Technical Bulletin

235

Mono Input Main Board

Modification of the Direct Output of the VeniceF Mono Input Channels from Post EQ Pre Fader to Post Fader

REV 1 VN201A MONO INPUT PCX-VN201A-B

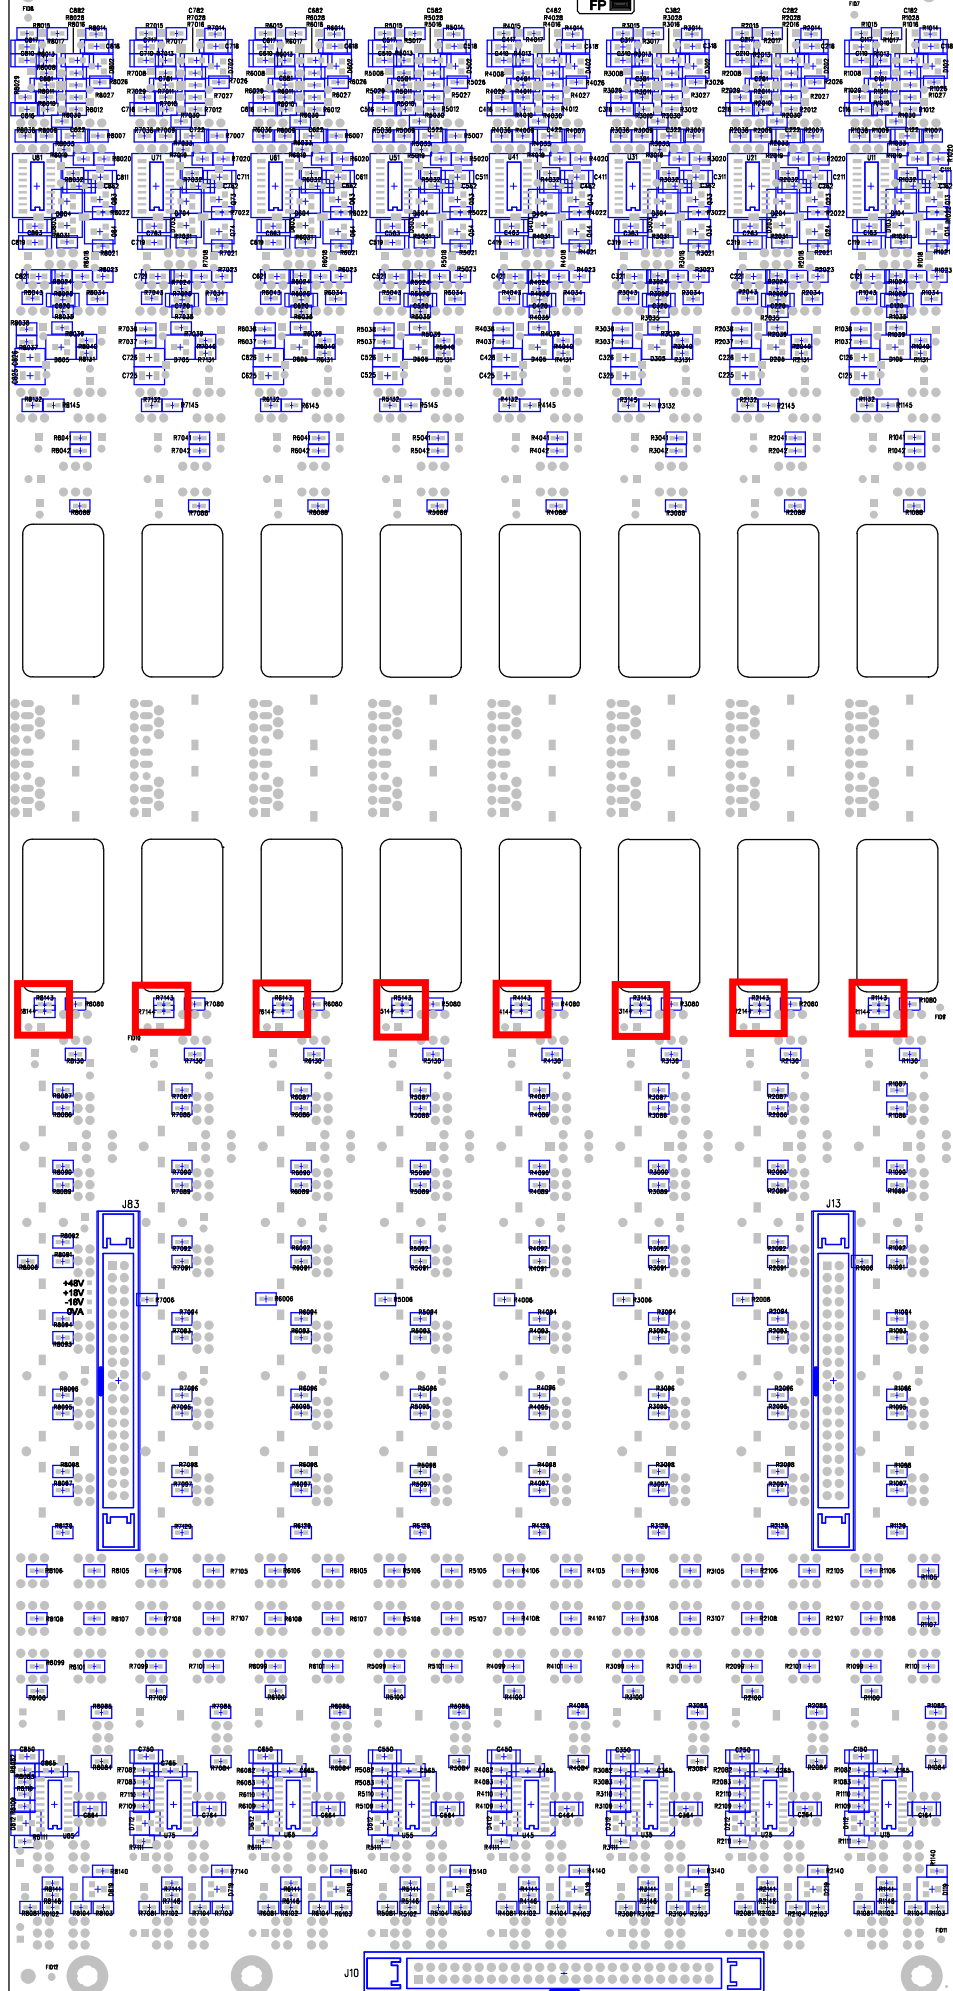
Option 2 can be changed to Post EQ - Post Fader by de-soldering an internal resistor link and re-soldering a new link into the new component positions shown below

Input Channel	Post EQ - Pre Fader Resistor Link	Post Fader Resistor Link
CH1	R1143 (fitted as Default)	R1144
CH2	R2143 (fitted as Default)	R2144
CH3	R3143 (fitted as Default)	R3144
CH4	R4143 (fitted as Default)	R4144
CH5	R5143 (fitted as Default)	R5144
CH6	R6143 (fitted as Default)	R6144
CH7	R7143 (fitted as Default)	R7144
CH8	R8143 (fitted as Default)	R8144
